# UNITED STATES PATENT AND TRADEMARK OFFICE

10/622,221

<b>Office Action Summary</b>	<b>Application No.</b> 10/622,221	<b>Applicant(s)</b> O'SULLIVAN ET AL.	
	<b>Examiner</b> Aaron Roane	<b>Art Unit</b> 3769

Claims 1, 2, 4, 9-17, 19 and 22-29 are rejected under 35 U.S.C. 103(a) as being unpatentable over Cox et al. (U.S. Patent 6,161,543) in view of Whayne et al. (U.S. Patent 6,203,525 B1).

**FIGURE #1**

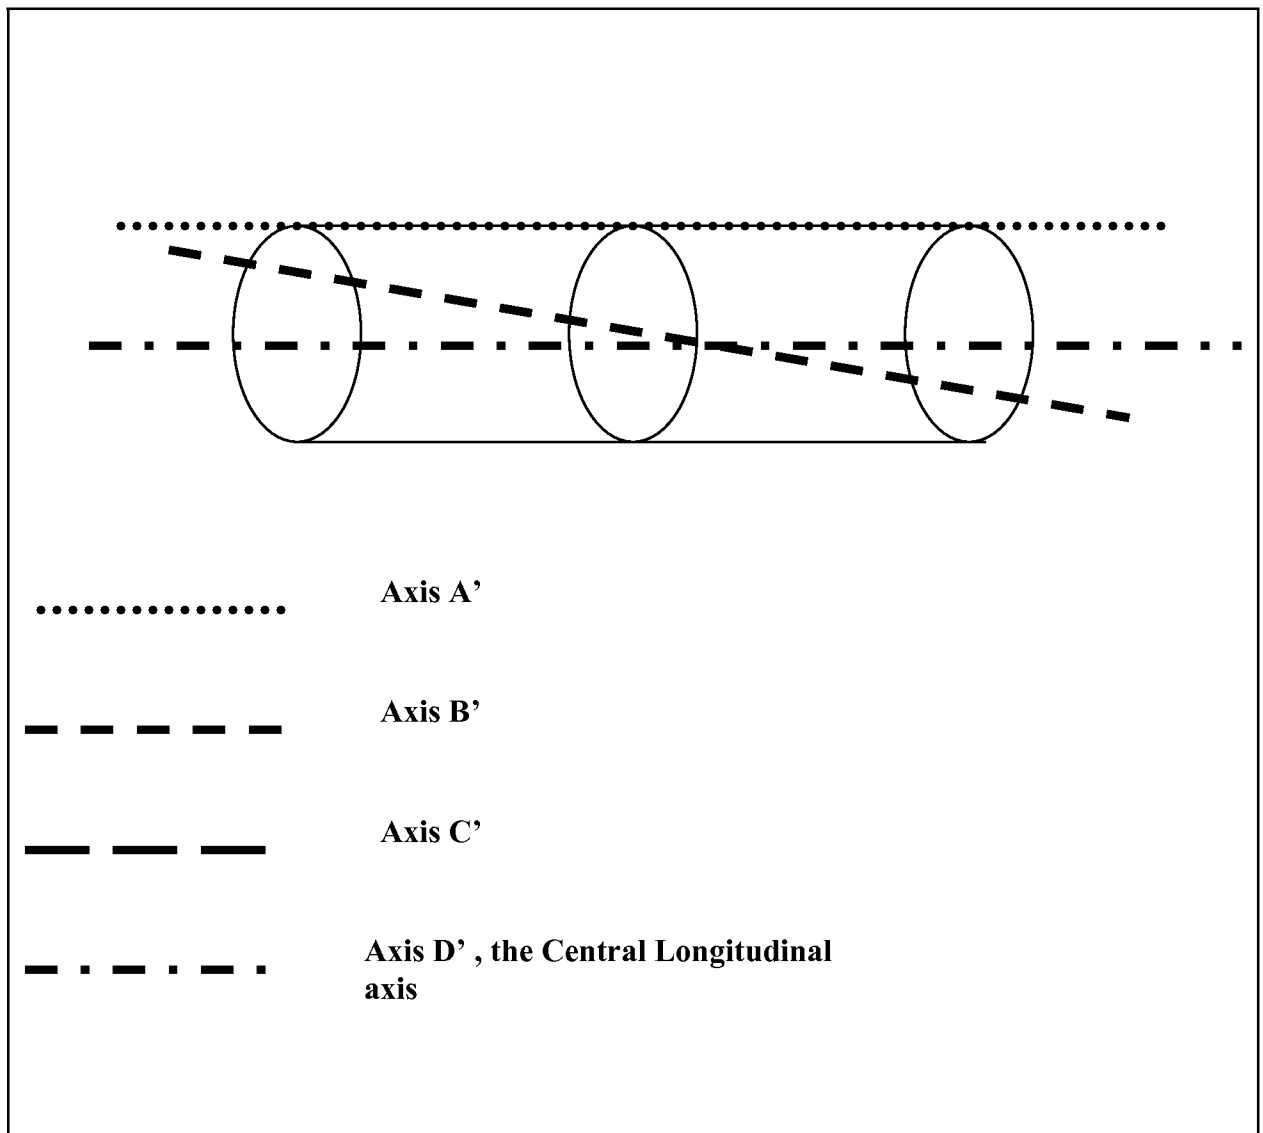
70, see figure 4 and its analogous counterparts in other embodiments) at the distal end of the catheter body, the ablation assembly including a generally-straight ablation arrangement that is generally transverse to the catheter body (see figures 4, 6A-D, 24, 27, 28, 33, 34 and 45), the ablation arrangement comprising: a non-conductive tubing (distal tubing 89 in figures 7 and 8A-C and its analogous counterpart in other embodiments) mounted on-the distal end of the catheter, the non-conductive tubing has a pre-formed generally heel-shaped curve comprising a first bend away from the axis of the catheter body and a second bend back toward and past the axis of the catheter body and terminates in a generally straight distal end which end is generally transverse to the axis of the catheter body. Although, Cox et al. fail to disclose that the ablation assembly is a porous electrode, Cox et al. do disclose the use of various alternative/equivalent ablation energy delivery forms/means including cryogenic and RF, see col. 3, lines 36-44. It should further be noted that Cox et al. disclose the generally straight distal end of the non-conductive tubing forms an angle with the axis of the catheter body ranging from about 75° to about 110°, this is easily seen by a single example in which Cox et al. disclose the generally straight distal end being at angle of 90 with respect of the axis catheter body, see figures 5 and 9 col. 13:54 – col. 14:6 and “as best viewed in FIG. 12A, the upper section segment 162 (half of the longitudinal right atrial lesion 50) is formed using a right angle probe 163 (FIG. 24) having a first elbow portion 166 positioned between the generally straight elongated shaft 66 and the generally straight ablating end. The first elbow portion has an arc length of about 85° to about 95° and a radius of curvature of about 3.2 mm to about 6.4 mm. The ablating end 70 is preferably about 2.0 mm to about

4.0 mm in diameter, and about 2.0 cm to about 6.0 cm in length. In this configuration, the ablating surface 65 extends, circumferentially, from a distal end 165 thereof to just past an elbow portion 166 of the right angle probe 163,” see col. 17:64 – col. 18:15 and figures 12A and 24 specifically. **Furthermore, with respect to the claimed longitudinal axis, Applicant should appreciate just how broad “longitudinal axis” is. An axis is broadly defined as a straight line, wherein at least a portion of which passes through a body or figure that satisfies certain conditions.” Here the certain conditions are longitudinal in nature. That is a “longitudinal axis” is broadly interpreted as a straight line at has at least a portion of which passes through a body or figure in a generally proximal to distal manner and/or vice-versa. It should be noted that the axes A’, B’, C’ and D’ are all examples of longitudinal axes of a tube, tubing and/or tubular member, see FIGURE #1 below. It should further be noted axis D’ is a special longitudinal axis of the tubular member, in that it is the most symmetric longitudinal axis. Finally, Applicant should appreciate how FIGURE #2 below demonstrates there is at least configuration (and/or set of axes) wherein Cox et al. anticipate the recited angles and bends.** Wayne et al. disclose a catheter for ablating tissue and teach providing the device with a porous electrode assembly (362 in figure 36-39) mounted on non-conductive tubing (distal tubing 28 in figure 3A and its analogous counterpart 370 in the embodiment illustrated in figure 36), comprising a porous sleeve (364) mounted in surrounding relation to the one or more electrodes; and one or more irrigation openings (374) fluidly connecting the open space to a lumen (lumen of 370) extending through the catheter through which fluid can pass; wherein, in

**FIGURE #2**

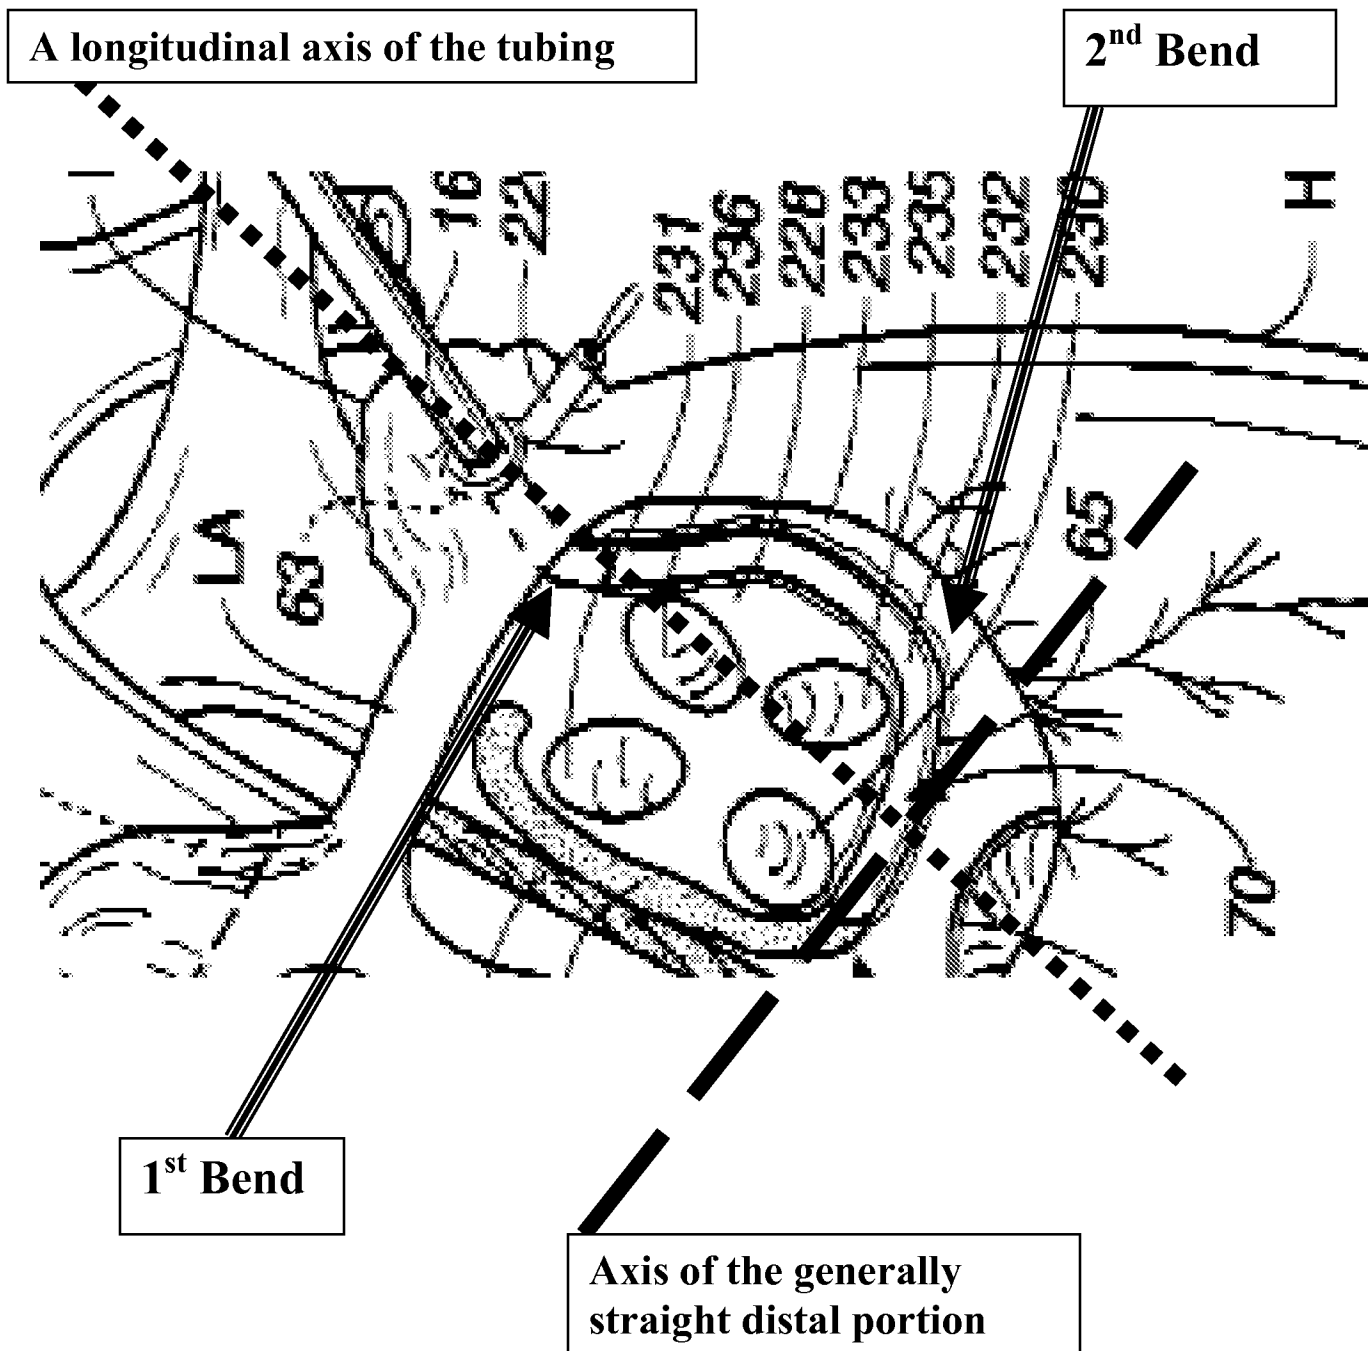
use, fluid passes through the lumen in the catheter, through the one or more irrigation openings, into the open space and through the porous sleeve, see col. 5, 6 and 21-23 and figures 1 and 36-39. Whayne et al. further disclose the one or more electrodes comprises a single coiled electrode (22/372) wrapped around a portion of the non-conductive tubing, see col. 5-8 and 23. Therefore at the time of the invention it would have been obvious to one of ordinary skill in the art to modify the invention of Cox et al., as taught by Whayne et al., to provide a porous electrode assembly located at the distal end of the catheter to serve as an RF ablation electrode in or to form lesions on the tissue.
